STAFF REPORT - AMENDED

Staff Report Number: 19-002-EQC

Regular Business: Issue determination on appeal of staff's approval of heritage tree permit for removal of seven redwood trees at 1000 El Camino Real

Southern Retaining Wall

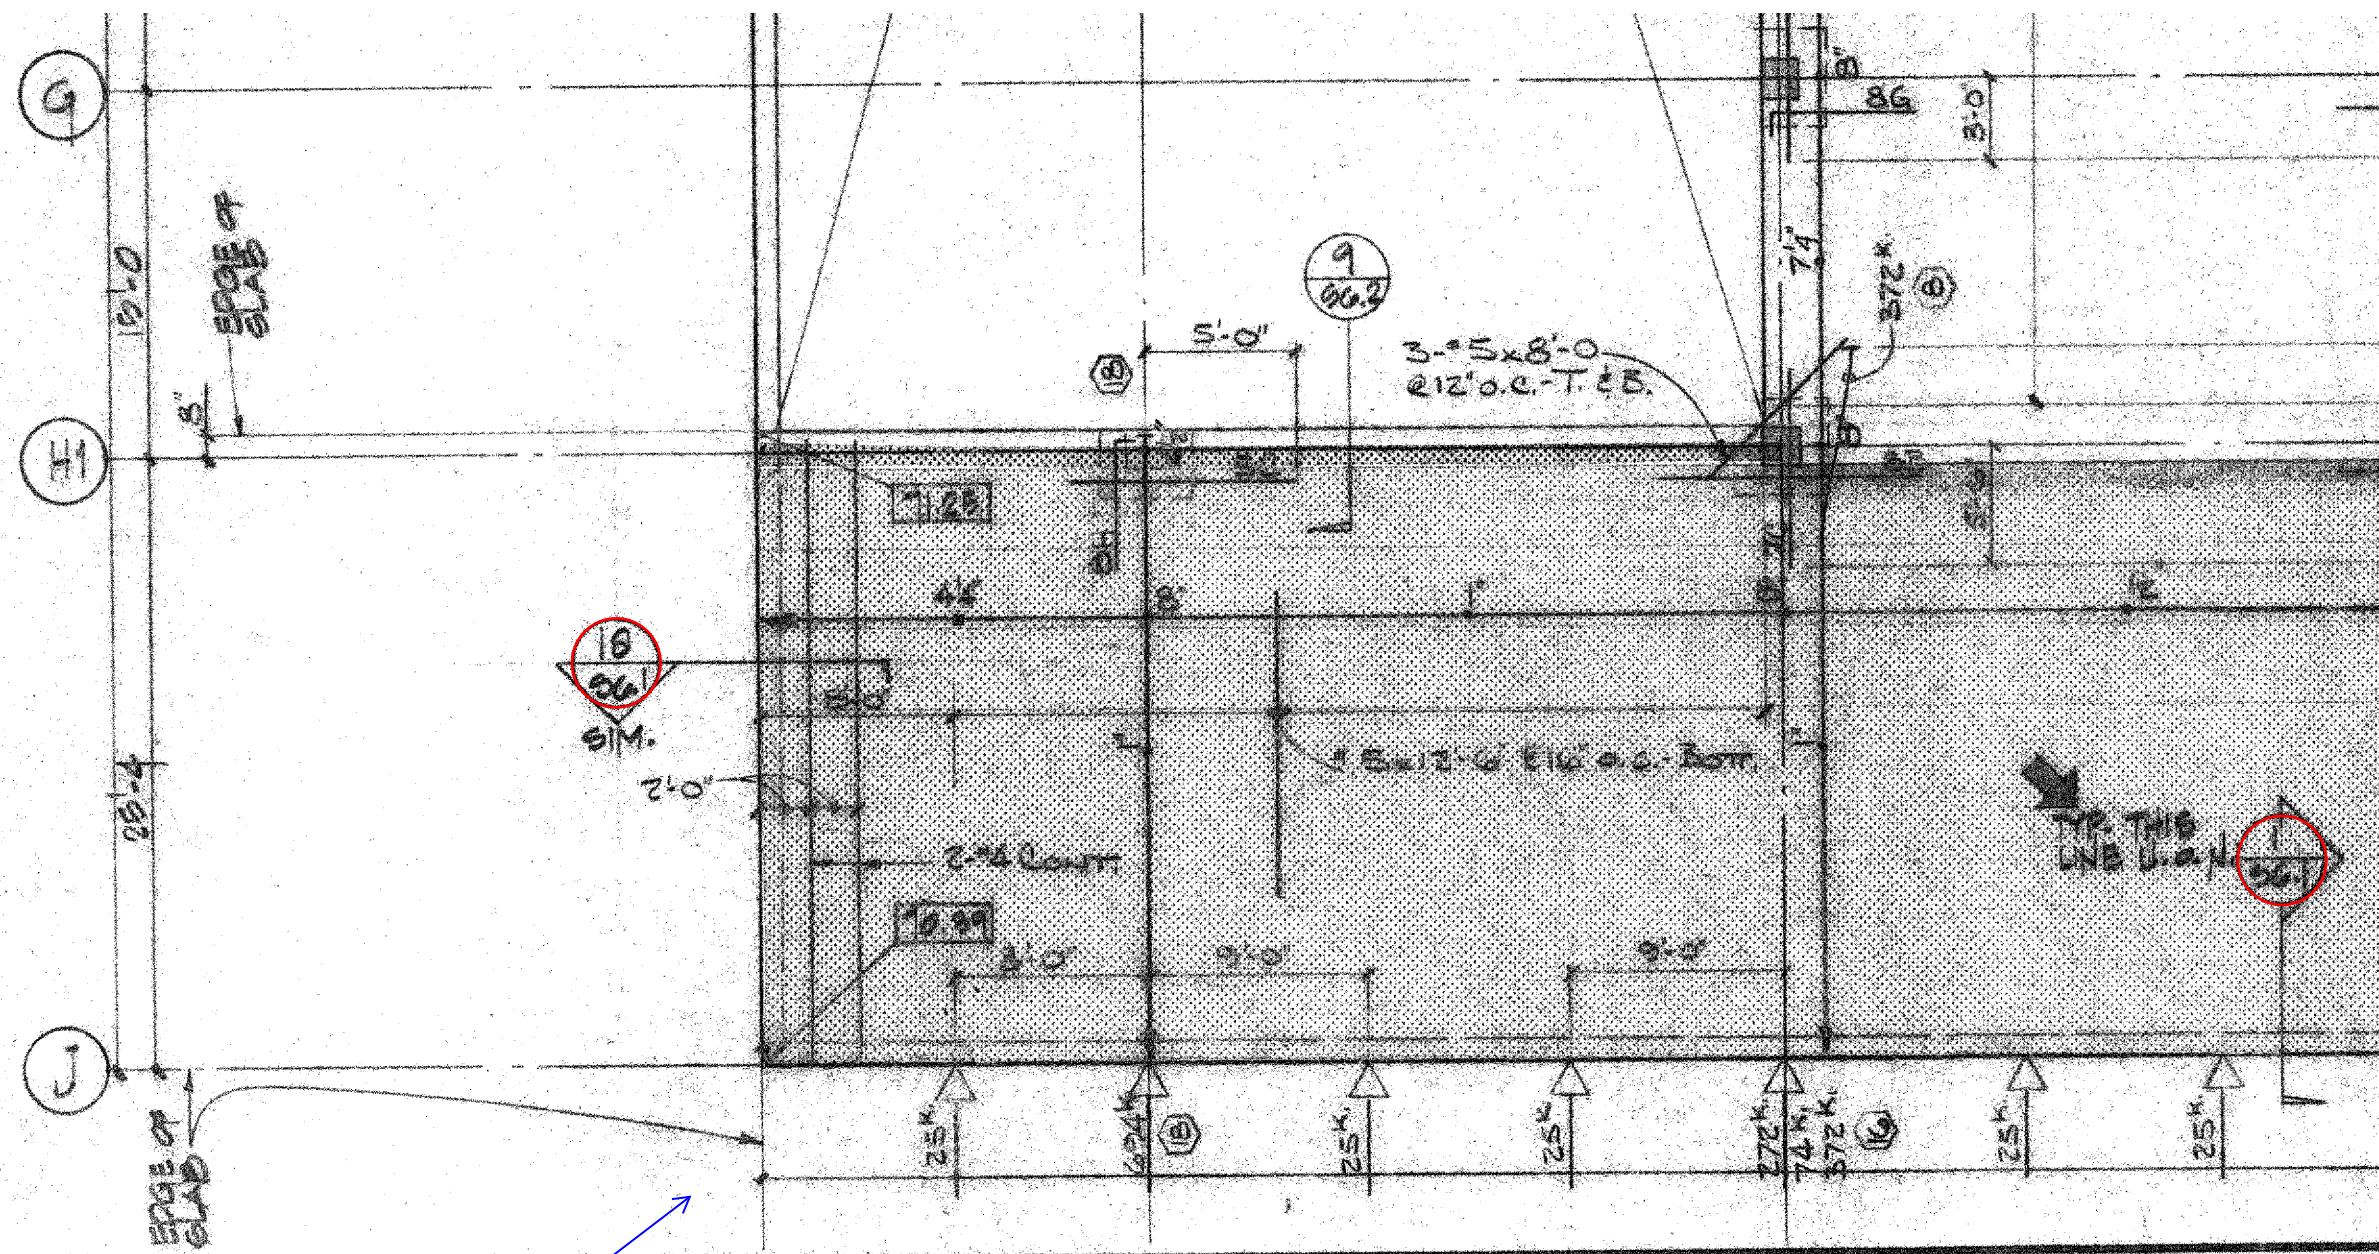
- The Hanging Garden proposal does not address the water seepage through the wall, the further degradation of the rebar and affects the structural integrity of the wall.

Layout plans and construction sections showing trees, primary root zones, and the construction access to repair podium slab

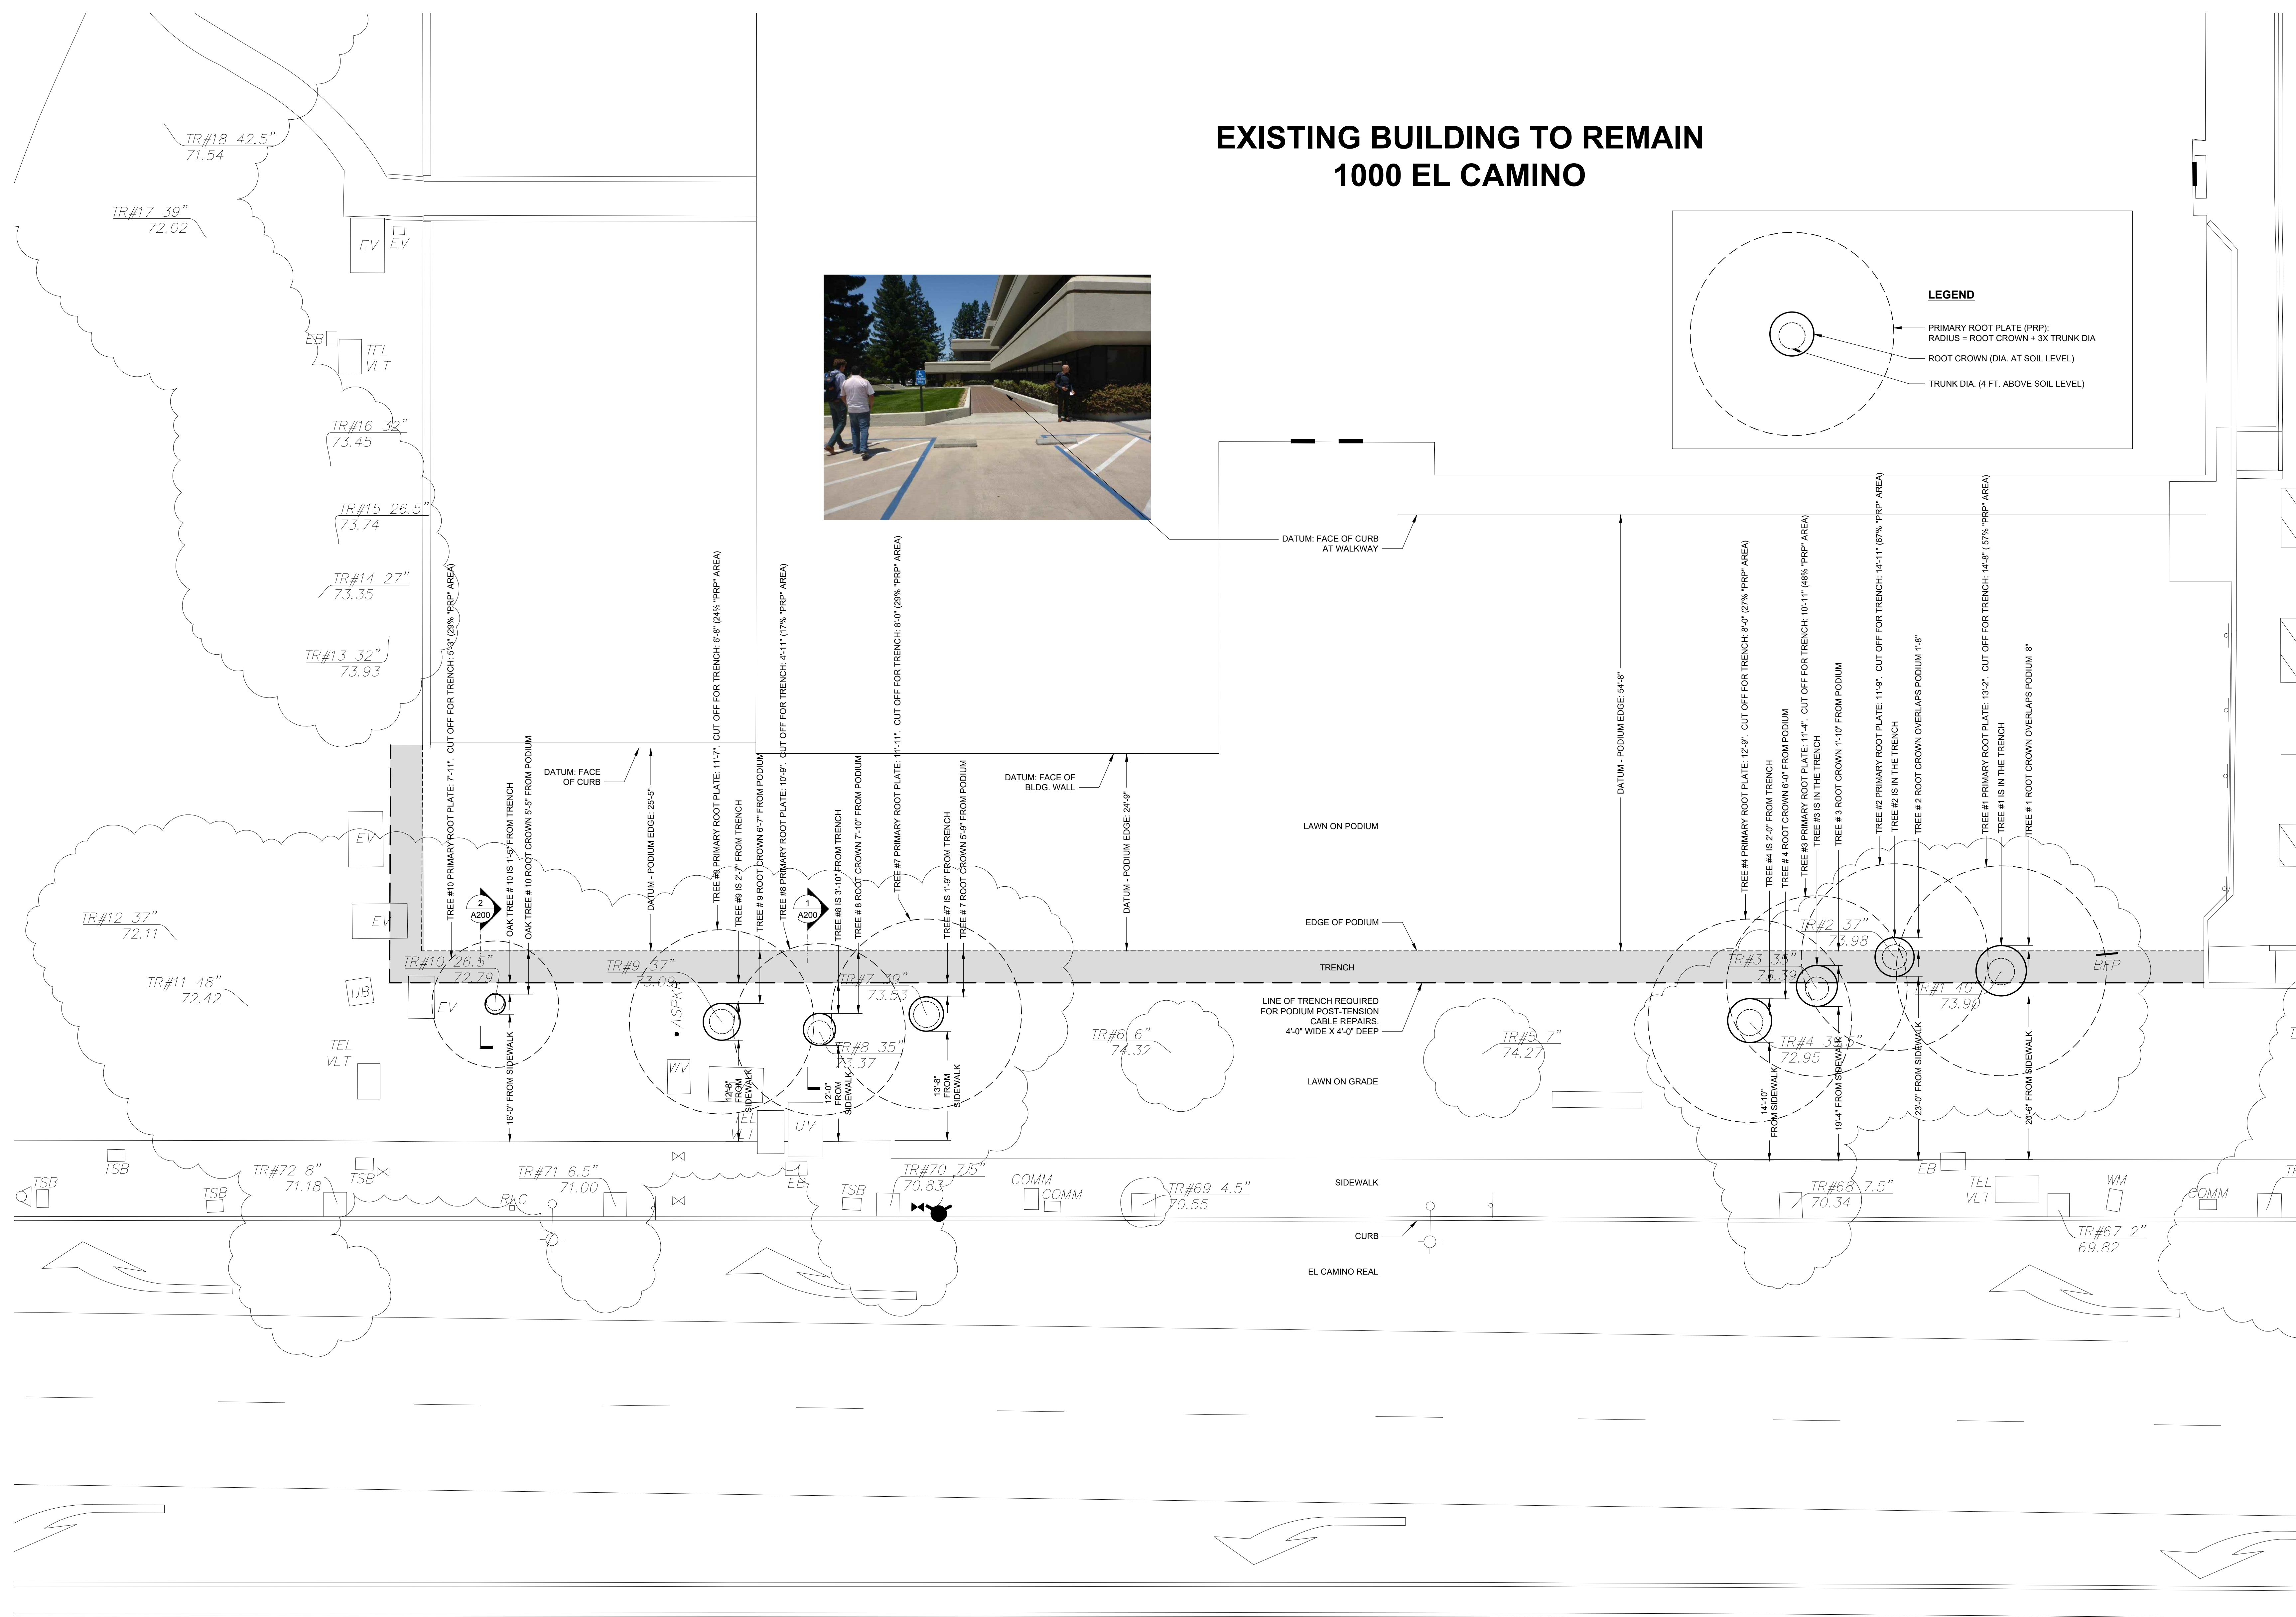
6. The arborist (SBCA) went on site and calculated the critical primary root zones of the trees along El Camino Real that are not recommended to be cut to maintain the health of the trees. The critical primary root zones are shown on Exhibit sheet A100.

7. At the El Camino side, the PT slab is buried under the dirt by 24" – 30". As seen on the plan view sheet A100 attached, the necessary 4' trench for access to perform the work

If the threshold for tree stability associated with root severance is three times the diameter of the tree, does the proposed plan exceed that limit? The answer is yes (Table 1, following page). I used Sheet 100 to determine the distances from the tree trunk and edge of the trunk to the podium wall and edge of excavation. The edge of excavation is within three times the trunk diameter limit for all seven redwoods and the coast live oak.

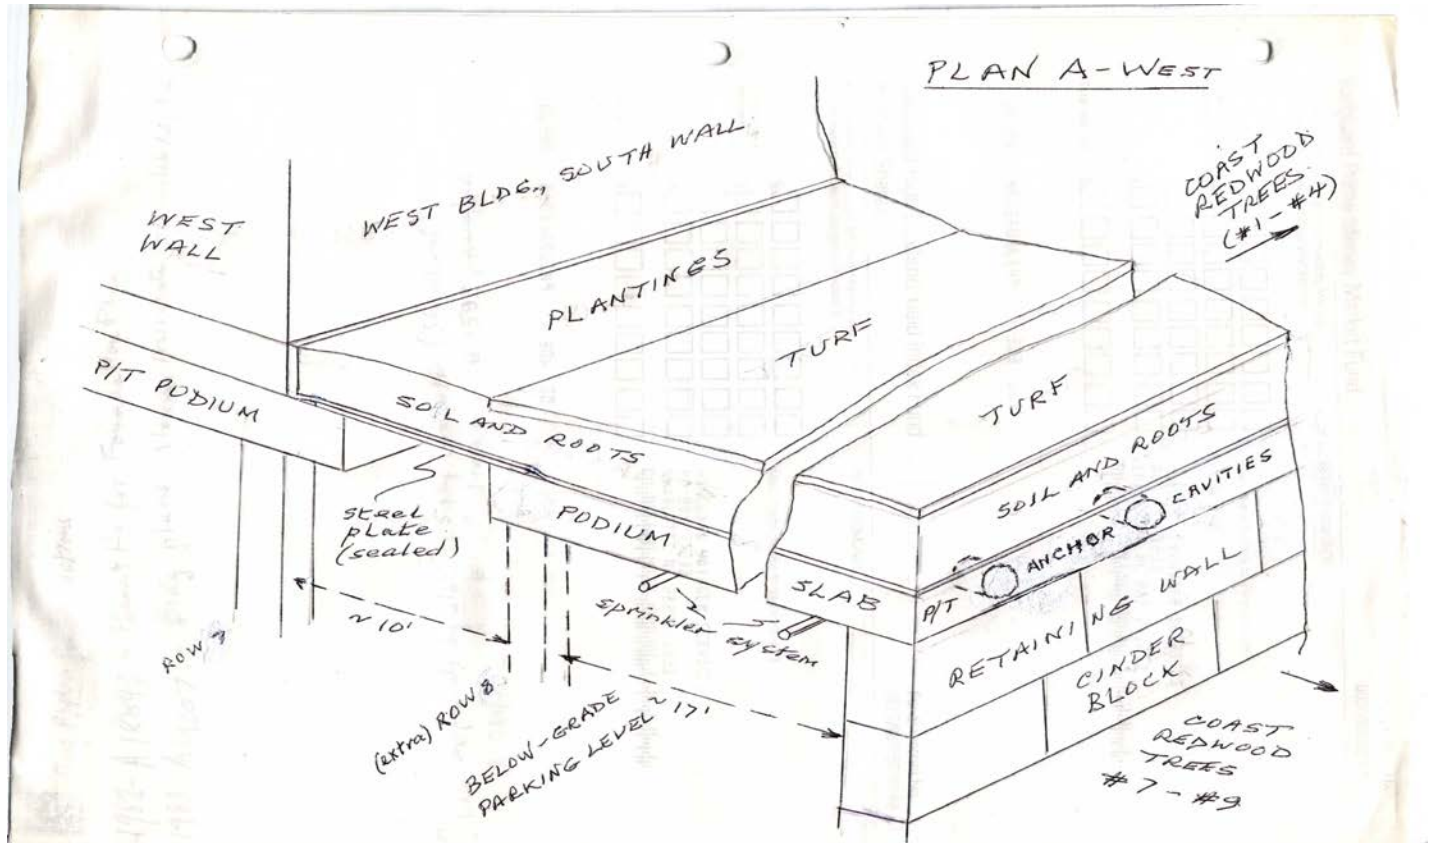
The (deceased) architect's plans (MP Building Dept. permit #A18843, 1982-83) of the Matteson buildings refer to ½" cables but illustrate only tendons.

Cutting across the podium slab in the west-east direction necessitates cutting all north-south cables/tendons running beneath the West and East Buildings, which would be dangerous to the operator, if they were still tensioned at 347-396 kilopounds/in² (A18843, Sheet S3.2-8 P/T Slab Detail).

To relax tensions, it is necessary to locate the north-south tensioning anchors. The (deceased) architect's plans do not indicate (to me) whether these are at the north or south edge of the podium slab or neither. The necessity for post-tensioning in 1983 would seem to preclude fixed anchors at both ends but I found no indication of any anchors other than fixed, button-ends in the plans; Sheet S3.2 is the only one designated for P/T Slab Detail in the index on Sheet A-0 of plans filed under Building Dept. permit #A19207).
